Mr. Luc Chouinard General Manager Agnico–Eagle Mines, Meadowbank Division Baker Lake Office

Report No 22 Meadowbank Mine Dike Review Board Meeting September 4-7, 2017

Photo #7 South Cell of TFS

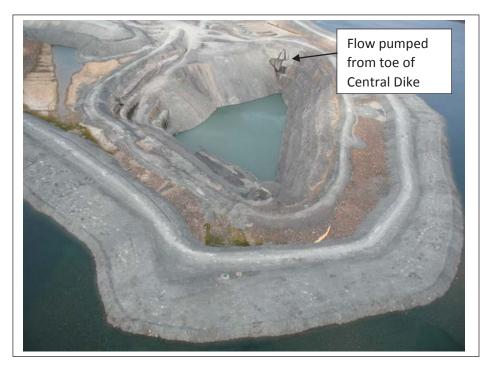
The Board recommends continuation of a deposition plan to encourage beaching along the SD-4 to SD-3 shoreline (Photo #7).

In view of the need to optimize tailings deposition that not only provides beaches along the geomembrane lined structures but also blankets suspected seepage entry points, a review of

the design criteria would be timely to ensure that all participants in the operation are working as efficiently as possible towards a common goal.
